SUBJECT: Responds to NRC RAI re analysis supporting deviations from BWROG Emergency Procedure Guidelines, Rev 4.

**SUSQUEHANNA STEAM ELECTRIC STATION
RESPONSE TO REQUEST FOR ADDITIONAL INFORMATION
REGARDING ANALYSIS SUPPORTING DEVIATIONS FROM THE
BWROG EMERGENCY PROCEDURES GUIDELINES REV. 4.
PLA-4308**

Attachment: Answers to Follow-Up Questions

Figure 4.1-1
SABRE Results for MSIV-Closure ATWS with No Addition Failures (Water Level > TAF)

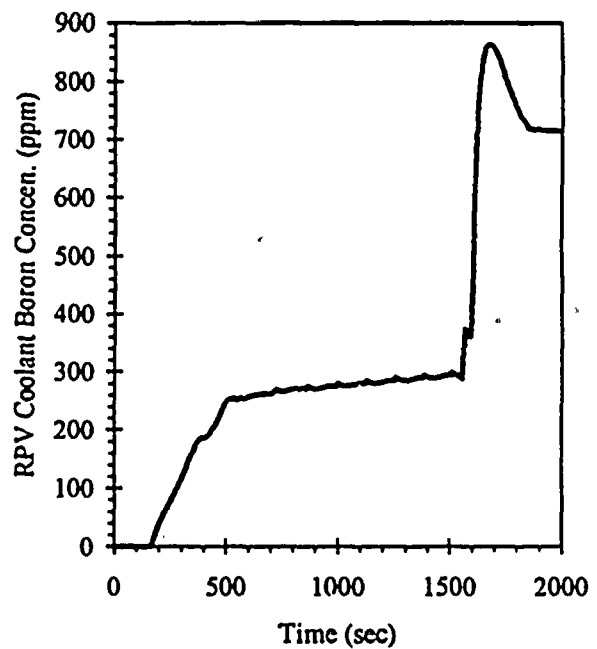
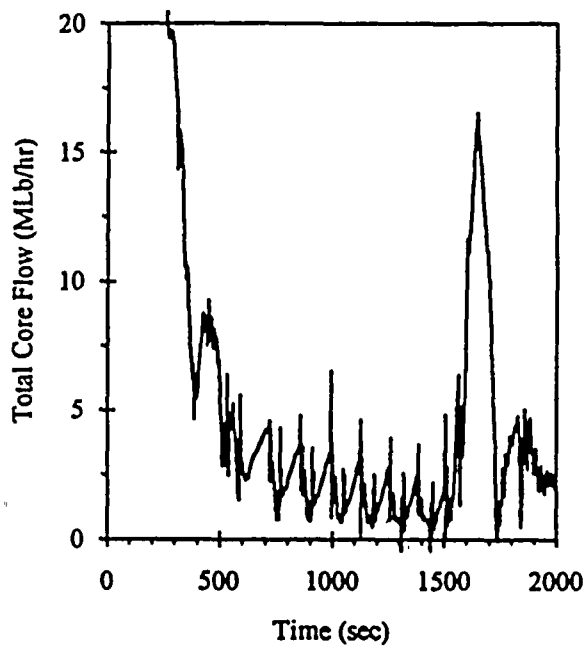
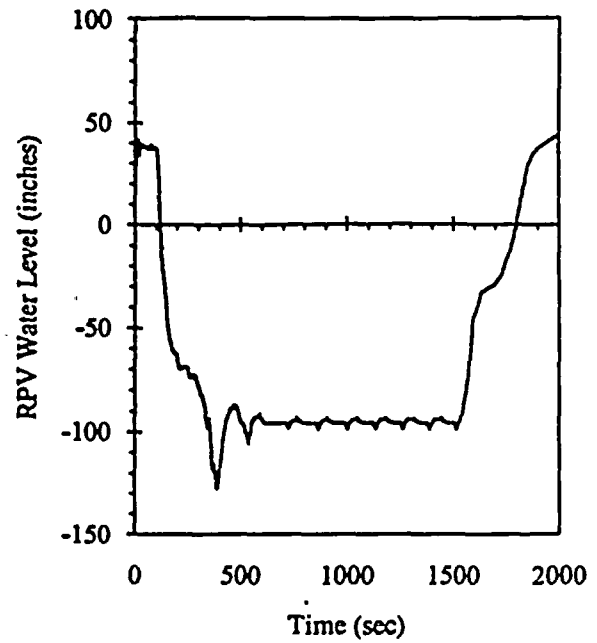
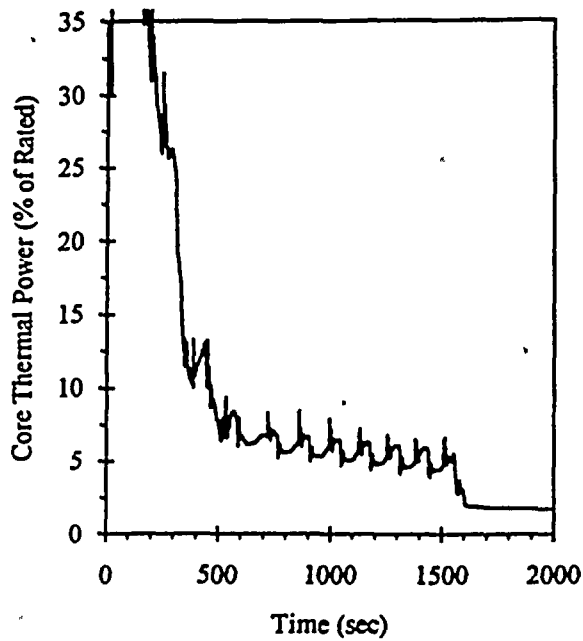
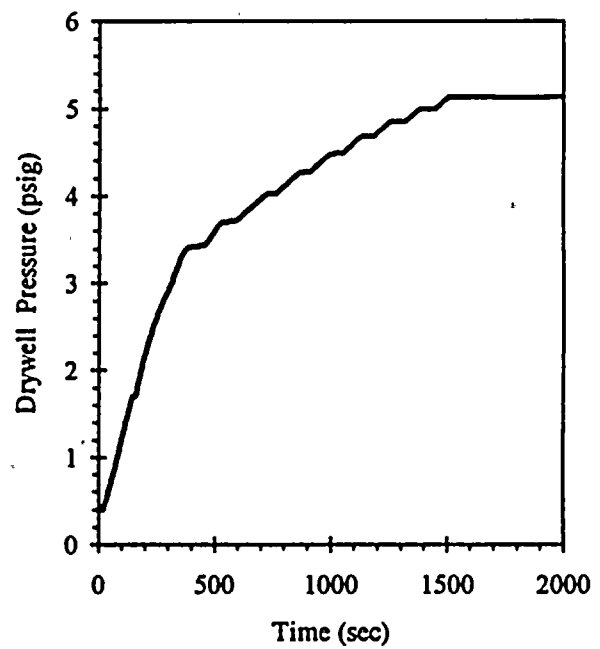
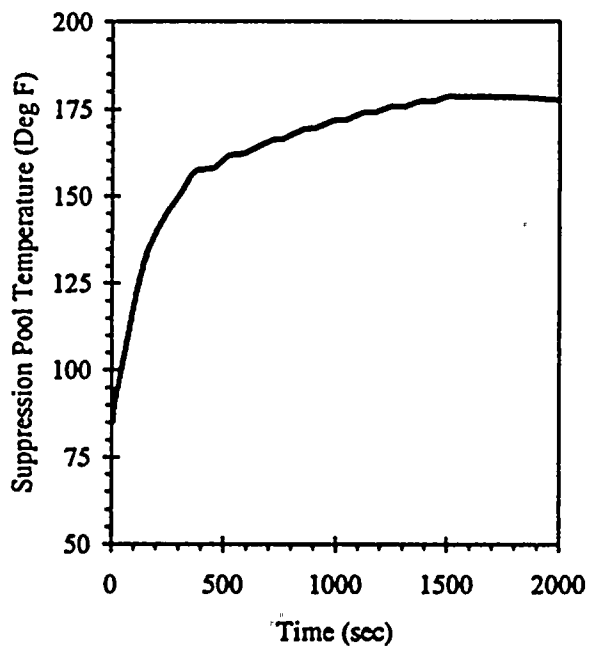
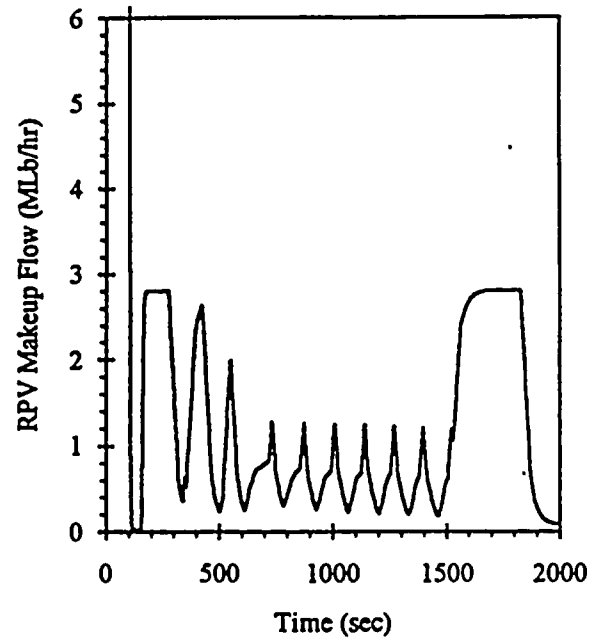
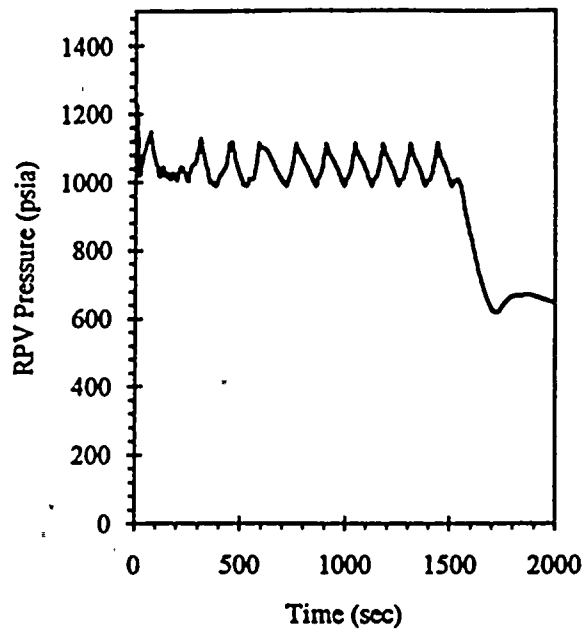
- (2) Provide data from SABRE runs for a MSIV closure ATWS with SLC at different water levels. The data that we are looking for is:
- (a) Power, flow, water level, and in-core boron concentration versus time
 - (b) Time to reach the stagnation flow
 - (c) Suppression pool temperature

The attached pages present SABRE calculation results for an MSIV closure ATWS with three different water level control strategies:

1. Above TAF with target band of -80 inches to -110 inches, PP&L strategy, (Table 4.1-1 and Figures 4.1-1 & 4.1-2),
2. Below TAF (Table 4.2-1 and Figures 4.2-1 & 4.2-1), and
3. No water level control (Figures 4.4-1 & 4.4-2).

4. In the PP&L strategy, HPCI and RCIC are allowed to initiate at their set points and inject to the vessel. Level is allowed to drop on its own without immediate throttling of injection flow. When the drop in level begins to slow down, the operator starts to throttle injection flow to drop level into the target region. This approach is consistent with PP&L procedures and operator training.

Figure Q3-1 SABRE calculation for MSIV closure ATWS with level control near TAF. HPCI and RCIC are used to control RPV water level. There is no boron injection or manual control rod insertion. SRVs actuate on individual setpoints which account for instrument drift.

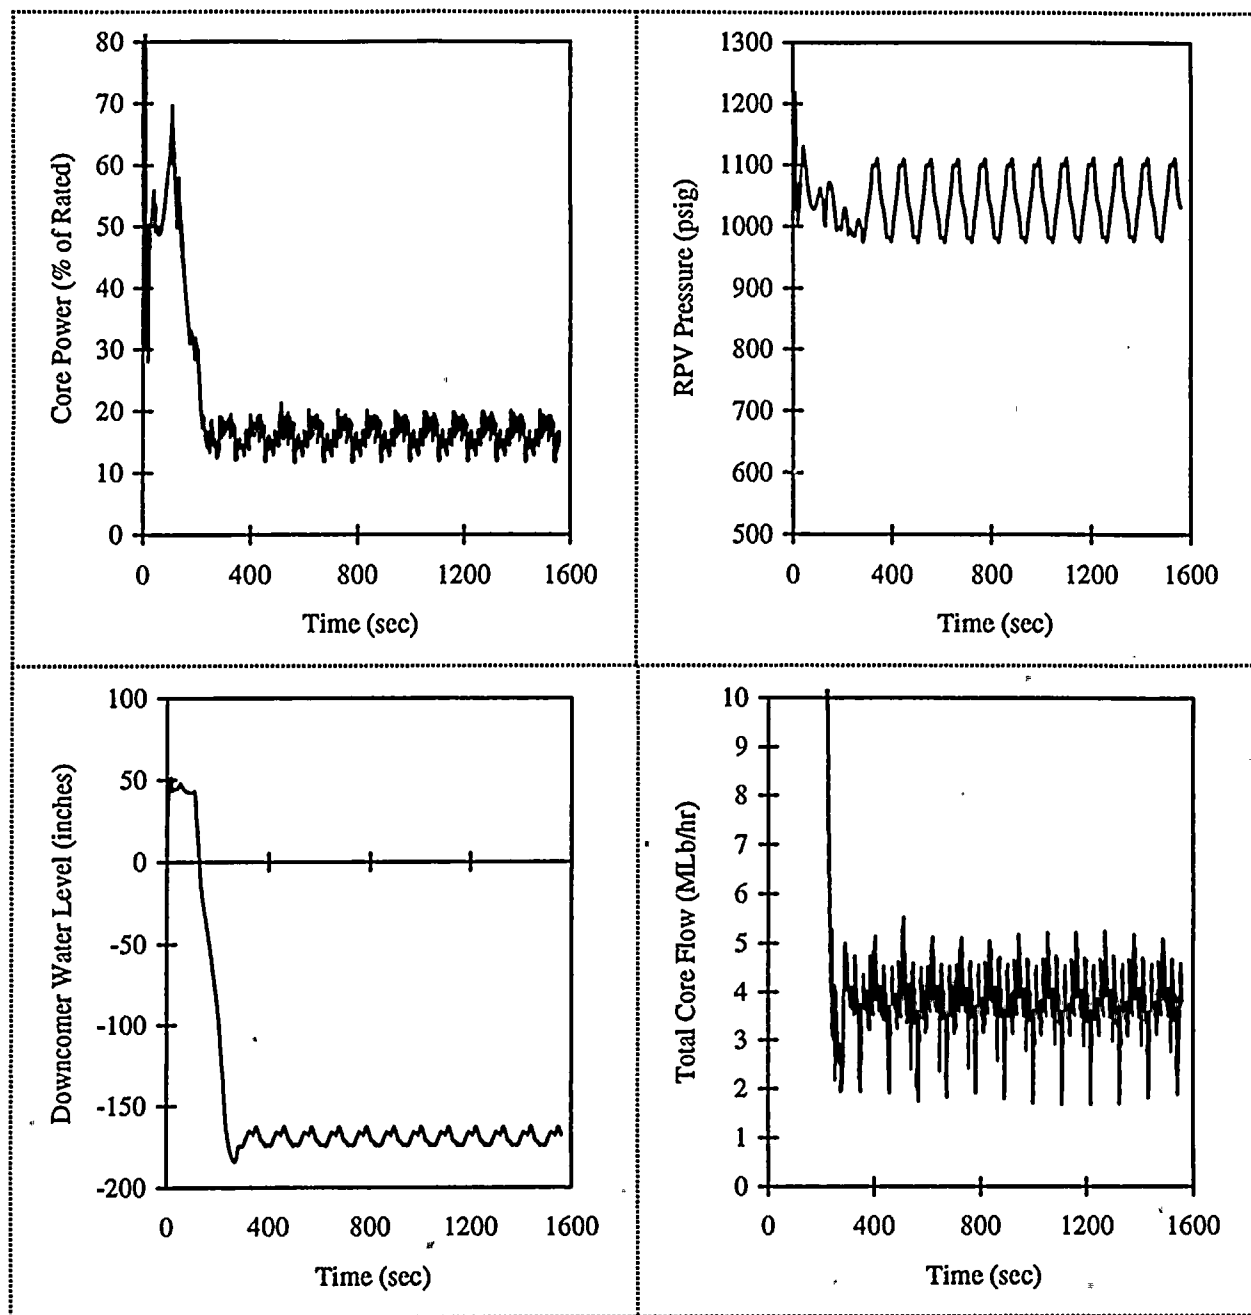
- (3) Data for run similar to the one documented in figs 2.1.2.4-1 of the old 1992 document (NE-92-001) - Water level at TAF with large power oscillations attributed to SRV with level at TAF using the improved models in SABRE.

Figure Q3-1 shows SABRE calculation results for an MSIV-closure ATWS with level maintained near TAF (-161"). In this case there is no boron injection or manual control rod insertion. Level is controlled near TAF using HPCI and RCIC. The results do not show the large power oscillations that were evident in the 1992 report NE-92-001. The current SABRE calculations show only small power oscillations as a result of the following two modeling improvements:

1. SRV set points are now staggered to allow for instrument drift. In the 1992 report (NE-92-001), SRVs actuated in groups so there was a stronger interaction between reactor pressure and core power/flow.
2. The SABRE flow model used in the 1992 report was restricted to the co-current flow regime. During SRV actuation, this flow model over-predicted the incursion of moderator into the core, and consequently, the power response was exaggerated. In the current version of SABRE, co-current and counter-current flow regimes can be described. This full-range flow model predicts a much more dampened flow response to pressure perturbations. As a result, power oscillations due to SRV cycling are well behaved.
